THE VOLVO OPEN 70 RULE

PUBLIC INTERPRETATION NO.21

MAST CROSS SECTION BELOW IG

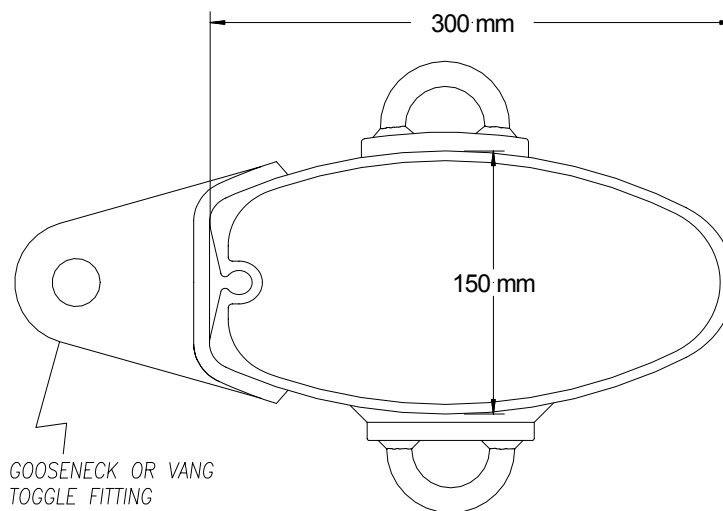
On the mast drawing below are 3 fittings that all extend outside the maximum dimensions of the mast. These fittings are rigidly fixed to the mast tube. On the side-walls of the mast tube are padeyes, with the lower padeye arrangement having a backing/packing plate. At the aft face of the mast tube is a gooseneck / vang fitting.

1. Does a mast with such fittings comply with rule 6.1.1(c)?

1. Yes. The external mast dimensions are related to the mast tube only. Additional fittings and external local stiffenings/reinforcements are not included in the measurement of these mast dimensions, with the exception of any mast groove or track as specified in rule 6.1.1(d).
